REGULATORY INFORMATION DISTRIBUTION SYSTEM (RIDS)

SUBJECT: Revised application for amend to License DPR-74, providing  
 addl info on frequency for torque testing ice condenser  
 inlet doors & capability to isolate containment svc air.Rept  
 on test dates & drawing of isolation valves encl.

Donald C. Cook Nuclear Plant Unit 2  
Docket No. 50-316  
License No. DPR-74  
AMENDMENT TO TECHNICAL SPECIFICATION CHANGE REQUEST

UNIT #1. LOWER ICE CONDENSER  
 Door 3-R 4/10/79  
 KAT.

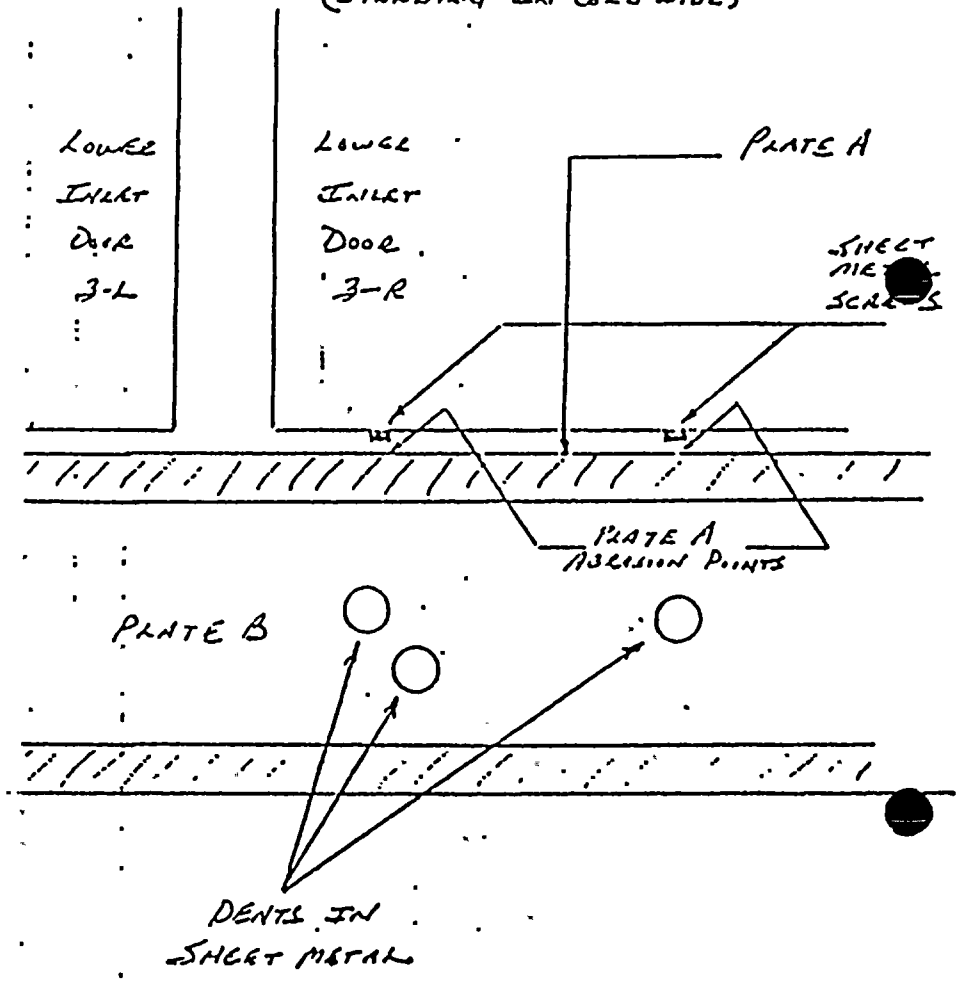
- 1) abrasion marks appeared on the door frame bottom ledge where two of the door's sheet metal screws were making contact as the door was opened,
- 2) large dents in plate B were observed directly below the abrasion points thereby suggesting that a mechanical force, imparted on plate B, may have resulted in forcing plate A upwards and also increasing the size of the gap between plates A & B,
- 3) the RTV sealant, previously installed in the gap between plates A & B, was found missing thereby allowing the possibility of condensation to run from atop plate A down into the insulation to freeze and push plate A upwards and
- 4) mineral residue, indicating condensation flow across plate A (from warm side to cold side) and down toward the gap between plates A & B, was observed.

\* CONTACT BETWEEN THESE TWO POINTS INDICATED BY ABRASION MARKS ON FRAME LEDGE (PLATE A)

To completely eliminate the possibility of this problem in the future, a RFC has been written to replace the horizontal plate A with a plate that would slope down in the direction as shown in Attachment #2. The sloping feature of the this plate would provide a significantly greater clearance between the plate and the door's sheet metal screws. The greater clearance will allow plate B to absorb impact without causing plate A to interfere with the door's opening travel. It is planned to install the RFC in each unit during each unit's upcoming refueling outage. (This has been completed)

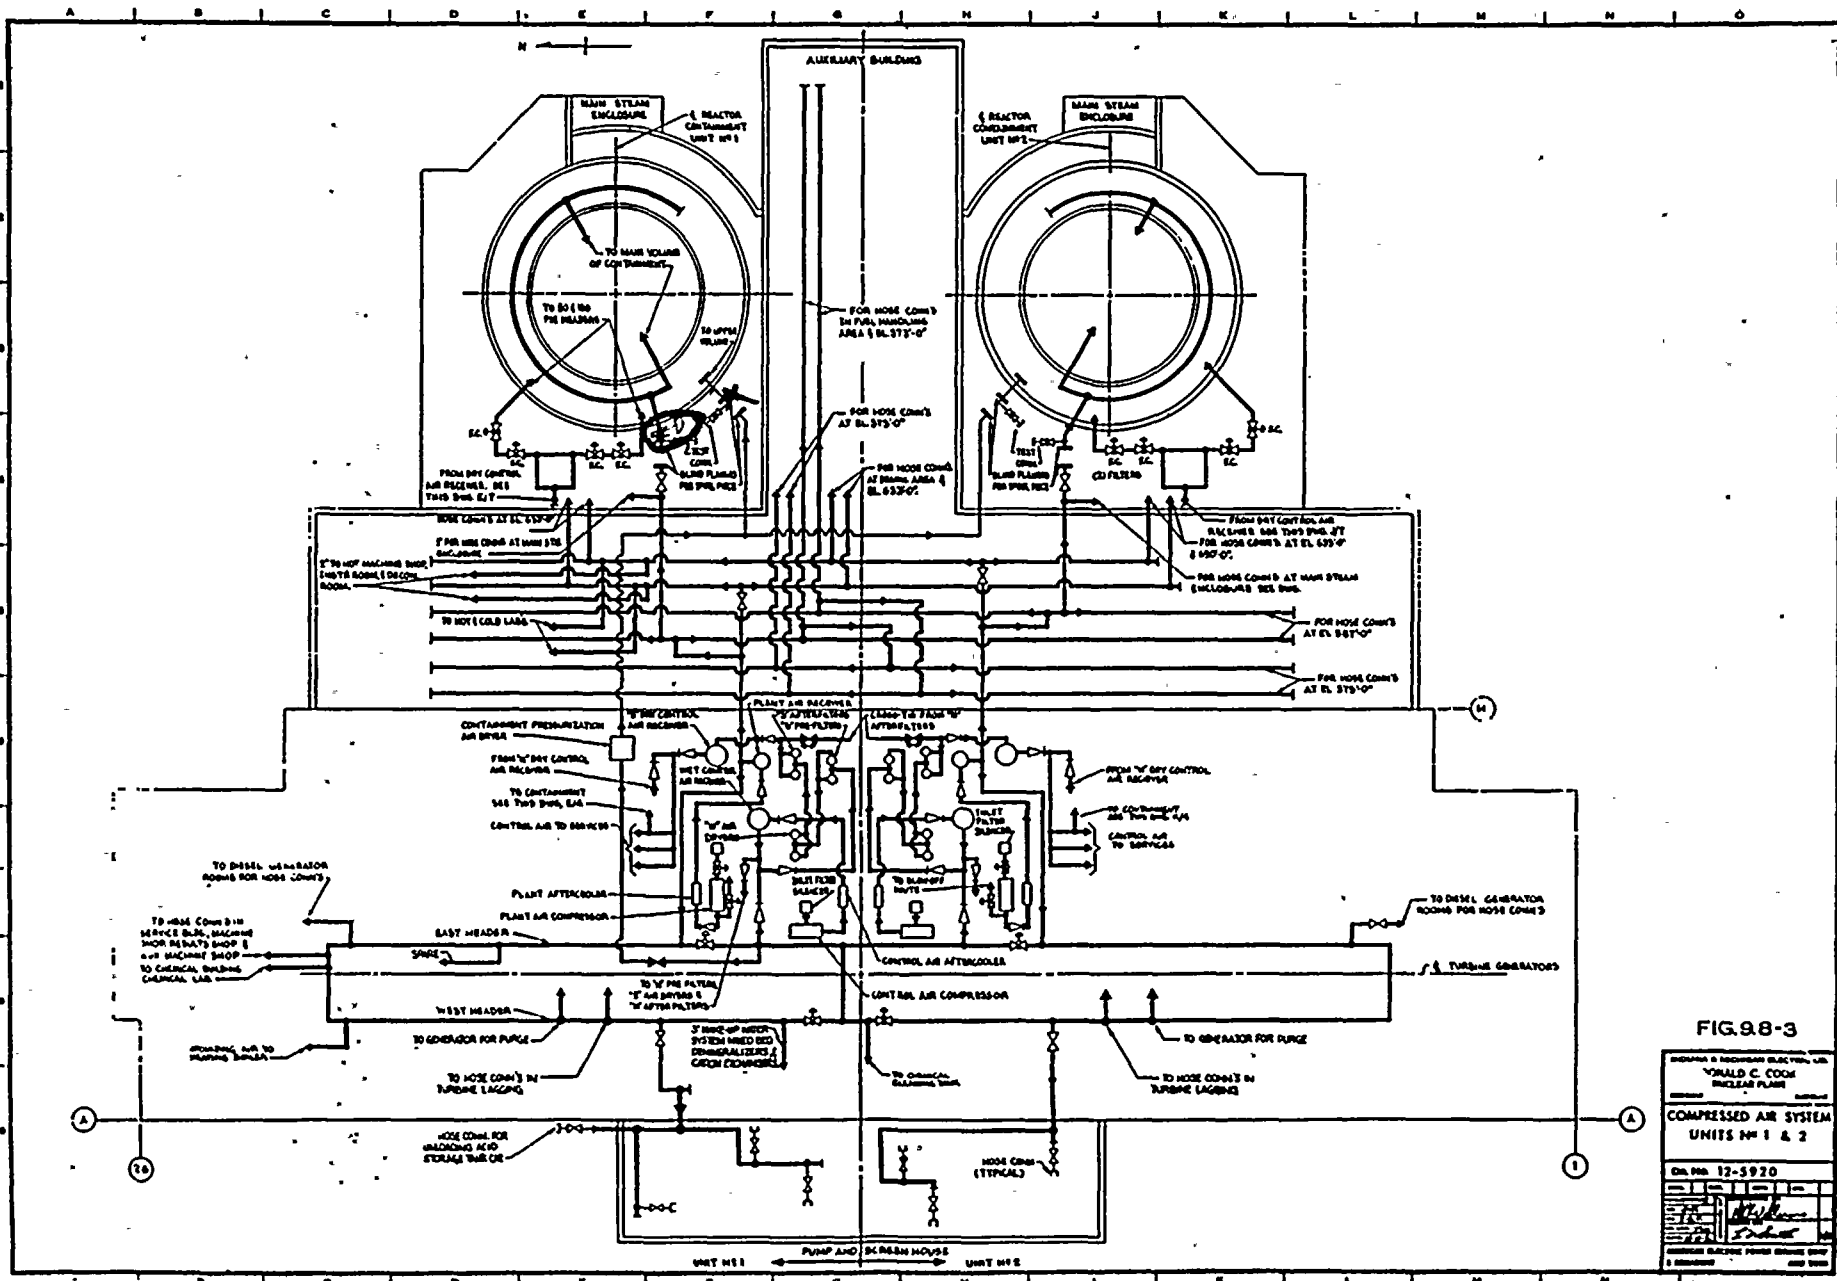
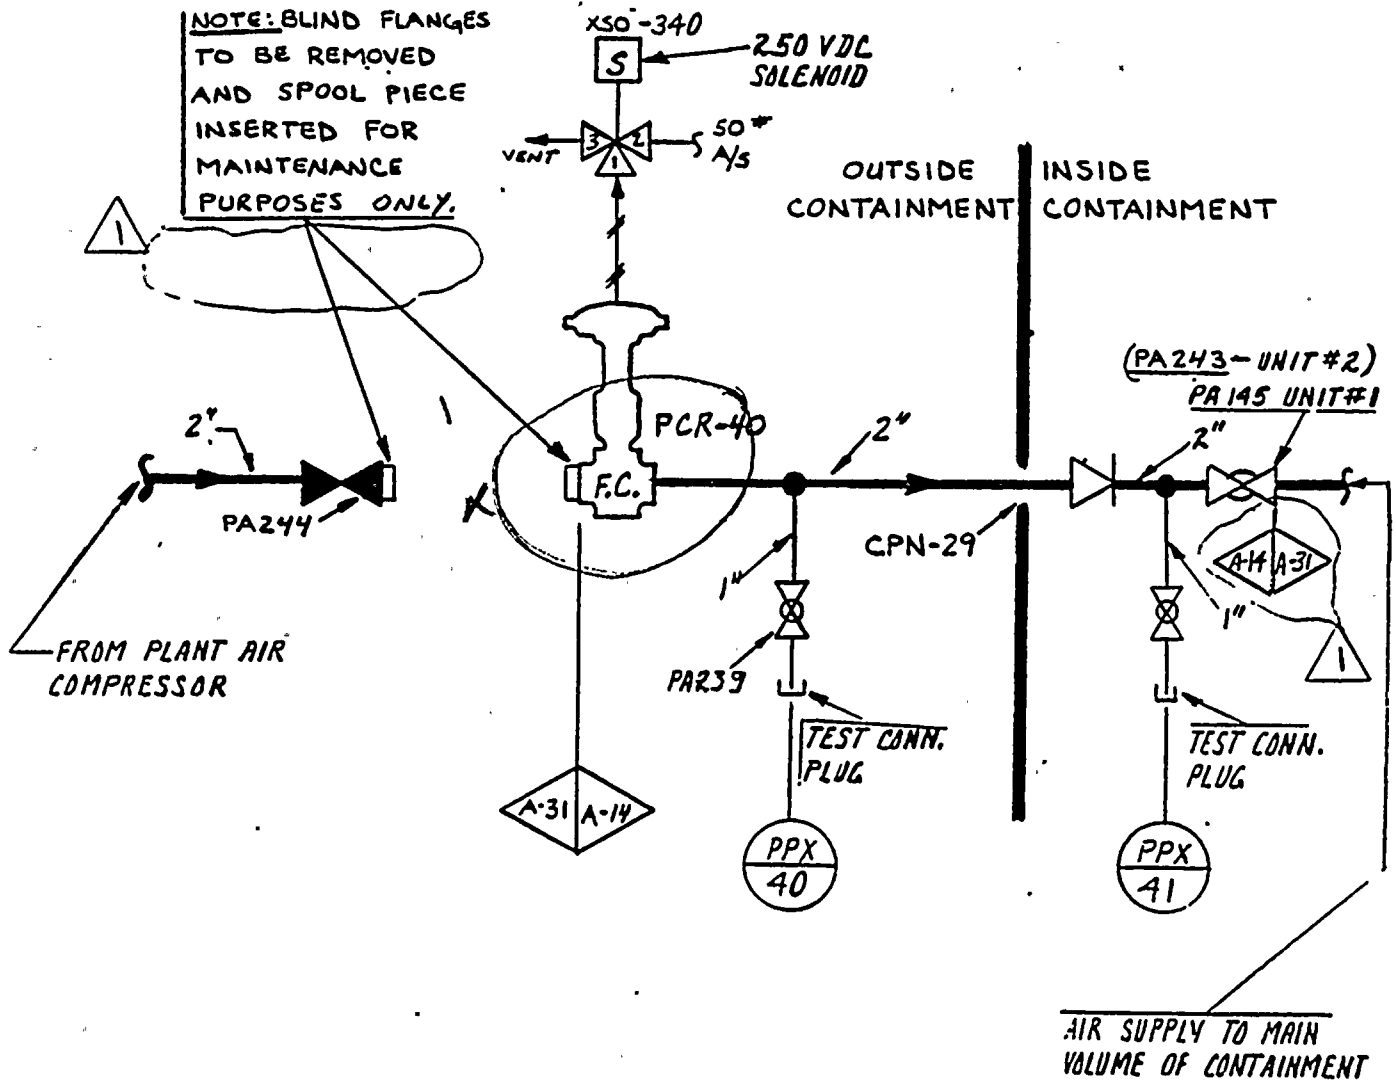
The fourth change involved the capability to isolate containment service air in Modes 1, 2, 3, and 4. Specifically, we requested Table 3.6-1 be changed to add valve PCR-40 to list A and valve PA-342 to list E and to delete valve PA-243 and a blind flange (Item 47) from list E. Attachment 2 to this letter contains a figure and drawing which show the location of the above valves. Figure 9.8.3 from the updated FSAR shows the physical location of the valves. Drawing 1-2-PO-01 shows the isometric location of the valve PCR-40, which would replace a manually operated valve at that location. Upon the initiation of the containment isolation signal, this valve is to close automatically, thus providing containment isolation.
